UNIVERSITY OF MINNESOTA
HEALTH SCIENCES EXPANSION

MEETING NOTES

TAC JOB: 75046, Unit B/C Materials Transport System

SUBJECT: Reorganization of the Medical Records Department

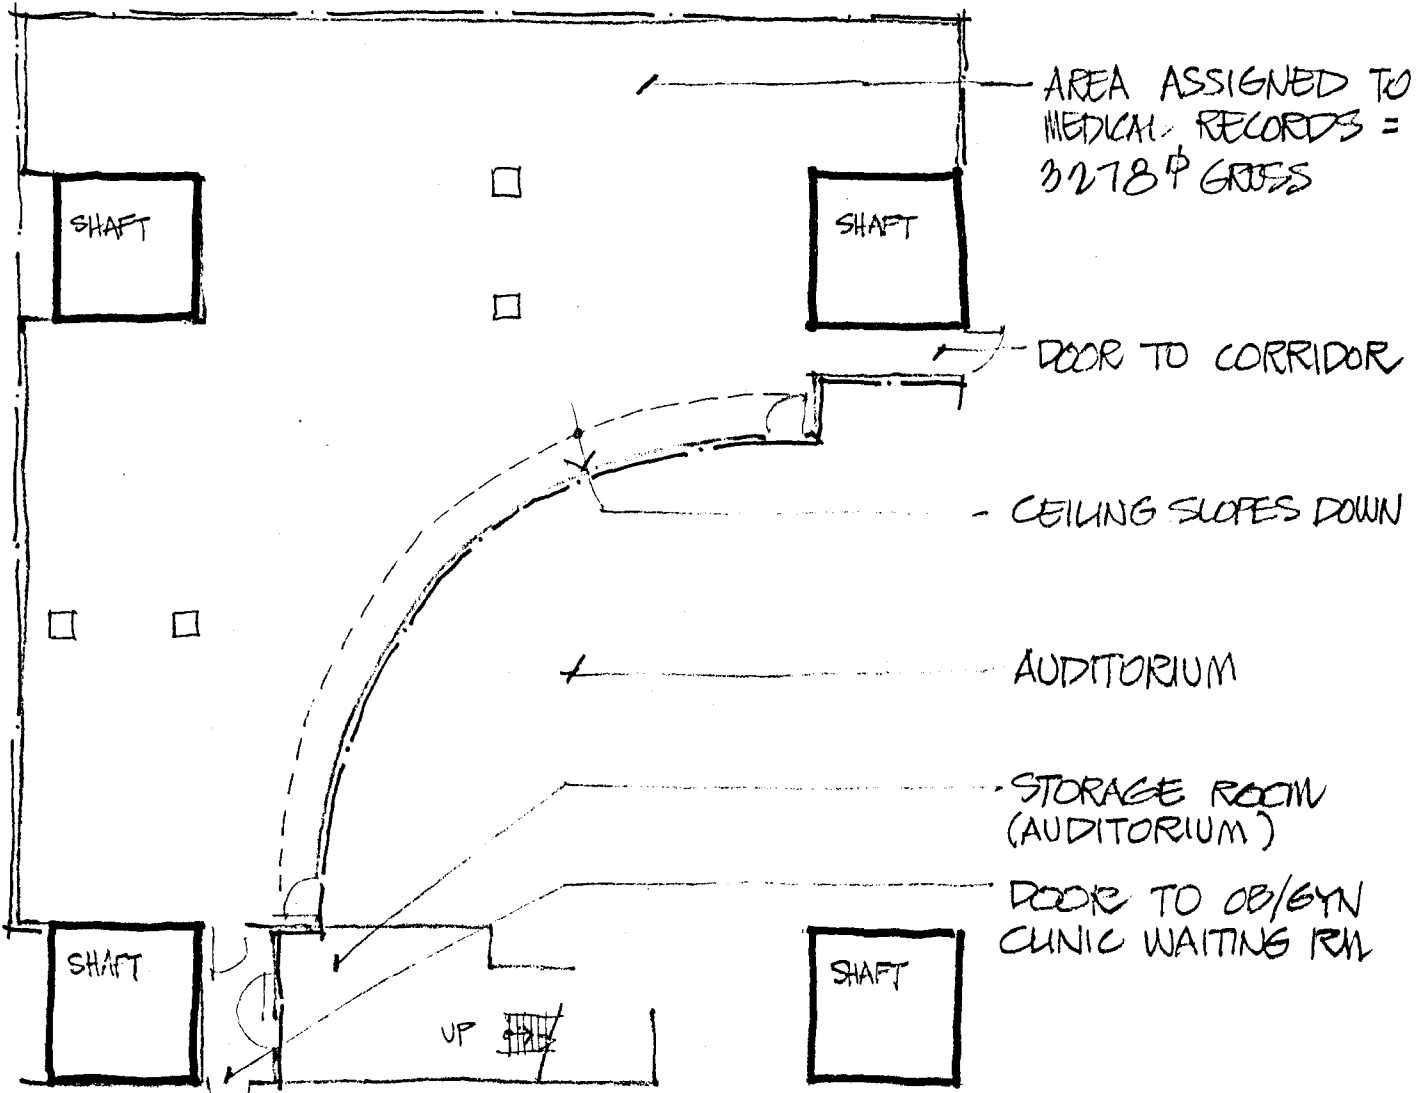
- a. The records receiving and distribution functions should be located at the corridor entrance to improve aspects of supervision and contact with the waiting room.

- b. The public and service entrances should be consolidated to improve control.
 - c. The office for the utilization review supervisor (Office 5) should be located with other office and conference functions near to the entrance and waiting room.

- d. Space is required for cart storage. Presently, six carts are used to distribute records to other departments and five carts are used in record processing.
